CITY OF FLORENCE, SOUTH CAROLINA
DESIGN REVIEW BOARD
JUNE 8, 2022 AGENDA

**CITY OF FLORENCE, SOUTH CAROLINA
DESIGN REVIEW BOARD
STAFF REPORT**

CASE NUMBER: DRB-2022-21

PROJECT DESCRIPTION: Installation of Window Security Bars

Attachment D: Site Photos

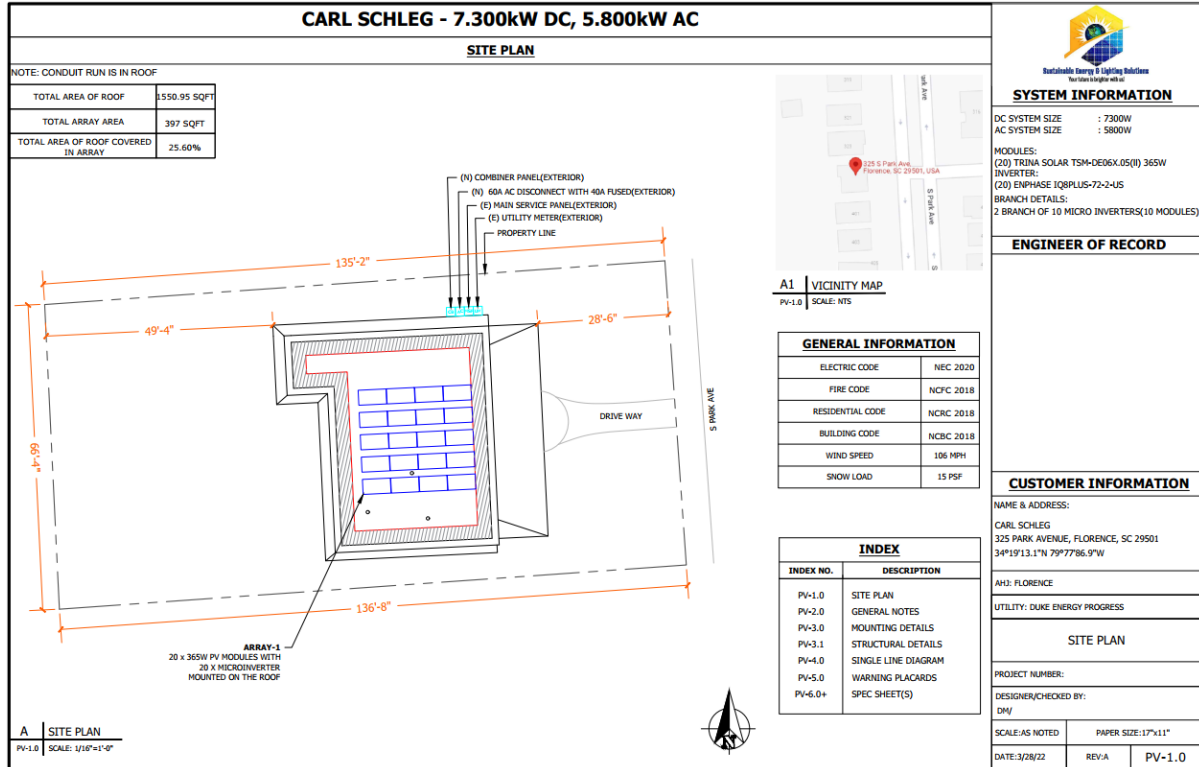
9. **The design of the roof should be compatible with the architectural style and character of existing buildings and surrounding structures:** *The roof design will not change; the solar panels will be installed directly on top of the existing flat roof.*

Attachment F: Building Elevations

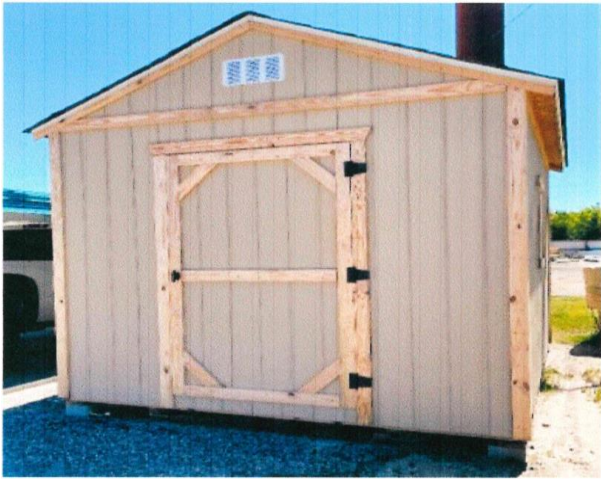
2. **Distinctive features, finishes, and construction techniques or examples that characterize a property should be preserved:** *The A-frame roof of the proposed storage buildings will be very similar to the roof pitch over the front porch of the home.*

6. **The height of any alteration or construction should be compatible with the style and character of the proposed or modified structure or building and with the surrounding buildings and structures:** *The heights of the proposed storage buildings (approximately 10') will be less than the height of the house in keeping with the UDO standard.*

9. **The design of the roof should be compatible with the architectural style and character of existing buildings and surrounding structures:** *The roof pitch of the accessory buildings is similar to the roof pitch found over the front porch of the principal building. The proposed buildings will have a gray, asphalt shingle roof.*
